# Access Compliance Report

## Public Rights-of-Way

Intersection ID: 10020375	Main Street: BALLANTYNE CORPORATE PL	Cross Street: N/A	Location: E
ADA ID: 5AA9CEEAD199	Ramp Type: BlendTrans2	Initial Pass/Fail: Fail	Overall Compliance: No
Severity Score: 12.5			
Codes/Mitigation Info/Possible Solution		Field Measurements/Component Compliance

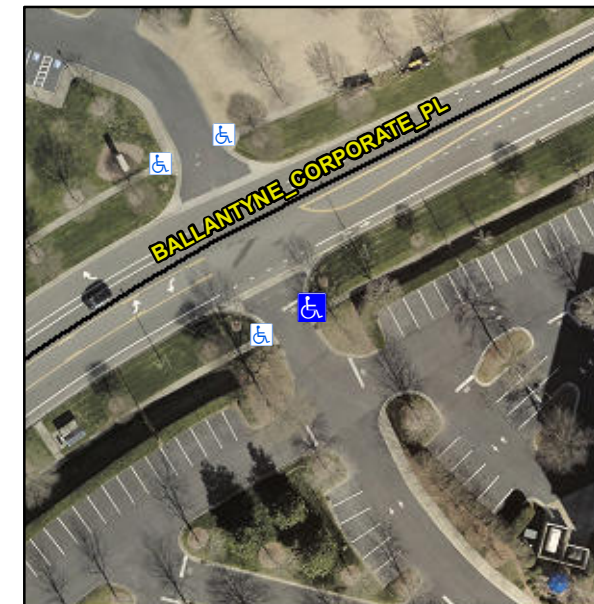
**Remove & Replace Curb Ramp With Two New Directional Ramps or Equivalent.**

**R304.5.3**
